From: jan.lehman7795@gmail.com
To: [Guequierre, John](#); [Parks, Timothy](#); [Plan Commission Comments](#)
Cc: ckarasov@gmail.com; patschubert@gmail.com
Subject: 6610-6706 Old Sauk Road Project.
Date: Thursday, March 14, 2024 10:11:04 AM

From: [Kathy Western](#)
To: [Guequierre, John](#); [Plan Commission Comments](#); [Parks, Timothy](#); [Fruhling, William](#); lzellers@cityofmadison.com
Subject: My Comments: Old Sauk Road / Pierstorff property 6610-6706
Date: Saturday, June 8, 2024 9:12:20 AM

From: [Jeff Western](#)
To: [Guequierre, John](#); [Parks, Timothy](#); [Plan Commission Comments](#)
Cc: [Stouder, Heather](#); [Wolfe, James](#)
Subject: Comments on Old Sauk Proposal – Watershed
Date: Monday, March 25, 2024 10:23:15 AM

Comments on Old Sauk Proposal – Watershed

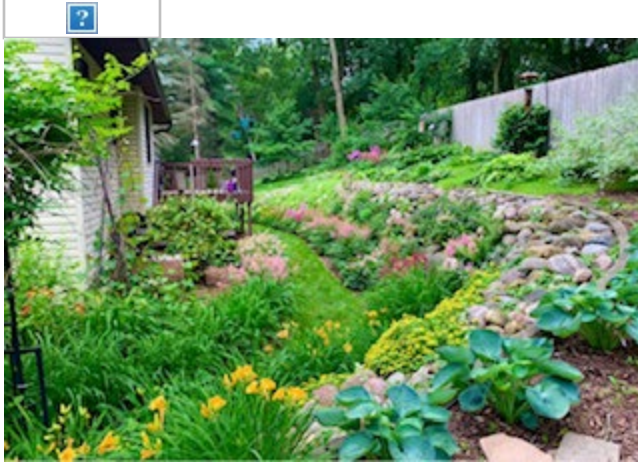
Unwanted noise and light traveling beyond our fence is noise and light pollution, invading our

private, quiet yard and home. SH's careless design, thoughtlessly creates a very busy 24/7 noisy access road, only feet from our quiet backyard, that all of the hundreds of cars, service vehicles and idling delivery trucks spewing exhaust fumes, will be forced to use. The access road is designed with parking stalls along the majority of our lot-line, with headlights facing our bedroom windows, to be right up to the backside of our fence. This ill conceived road leads to 100% of the parking, both the above ground stalls and to the underground parking, with only one entrance/exit for all those vehicles. There is also a loading area right behind our fence that will add to the chaotic jumble of vehicles with different objectives, all trying to be in a small area at the same time. What about the traffic jams with all those vehicles trying to get a parking place or trying to get in and out? The cars will be coming onto the access road at the same time as cars trying to leave. This sounds like a potential source of gridlock with a side order of road rage, leading to more chaos, more noise, nothing anybody who cherishes a quiet, peaceful backyard would want directly behind them.
